CITY OF KEY WEST

ADDENDUM NO. 1 CAROLINE STREET IMPROVEMENTS / ITB 15-007

This addendum is issued as supplemental information to the bid package for clarification or amending of certain matters of both a general and a technical nature. The referenced Invitation to Bid (ITB) package is hereby addended in accordance with the following items:

ORIGINAL - DECEMBER 2014
 CAROLINE STREET IMPROVEMENTS
 KEY WEST, FL 33040
 PARKING LOT PLAN

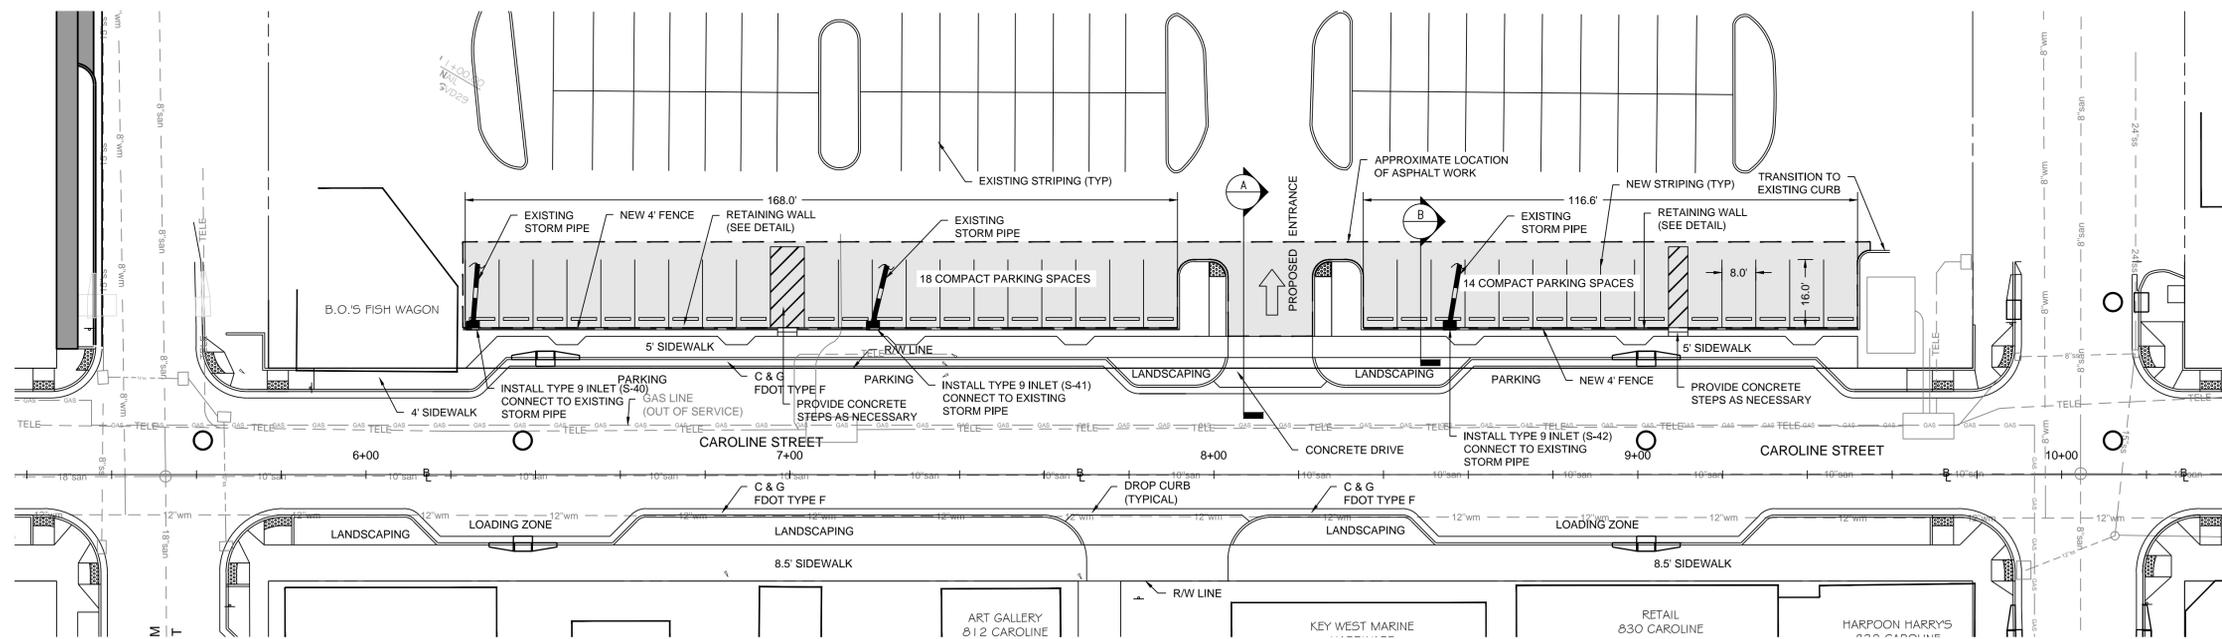
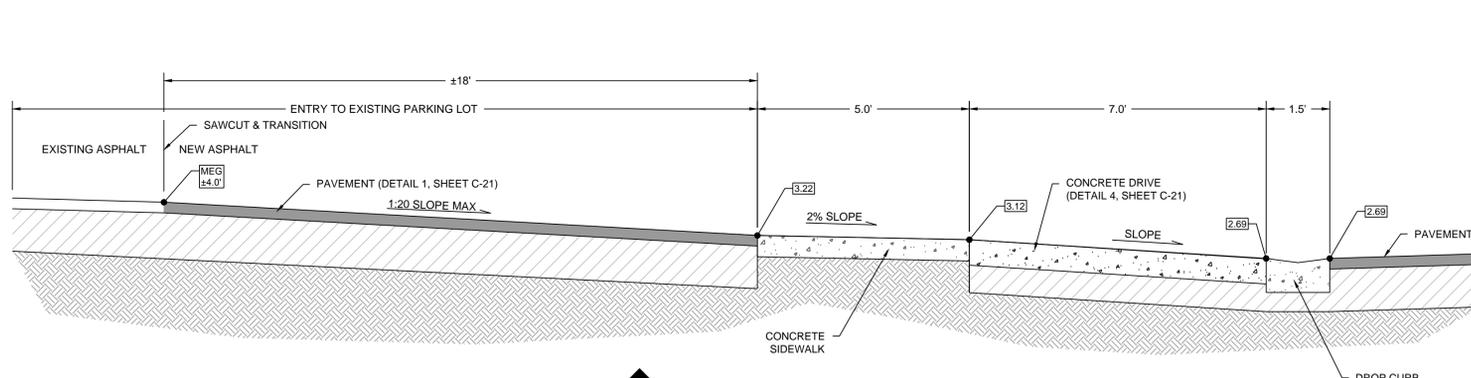
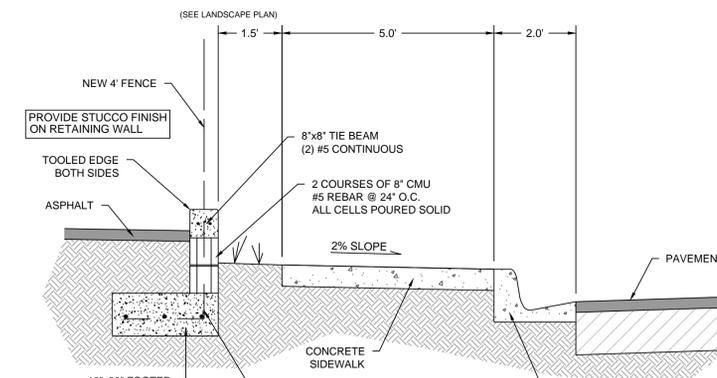
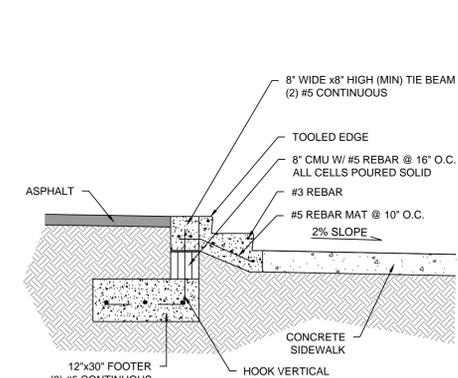
<u>Sheet(s)</u>	<u>Description</u>
E-2	LIGHTING PLAN – Corrected “Key Note” to revise lighting circuits to be 2-pole.
C-5	ROADWAY – Lengthened loading zone at approximately STA 8+45 to 72 feet
C-9	DRAINAGE PLAN AND PROFILE – Provided clarification of grading for Parking Garage ramp at approximately STA 13+28
C-10	SIGNING AND PAVEMENT MARKING PLAN – Revision of Loading Zone and Parking Space signage and striping locations and details
C-11	SIGNING AND PAVEMENT MARKING PLAN – Revision of Loading Zone and Parking Space signage and striping locations and details
C-19	PARKING LOT PLAN – Revision to add two (2) pedestrian access/egress points along proposed fence line, 5 feet wide each with steps as applicable.
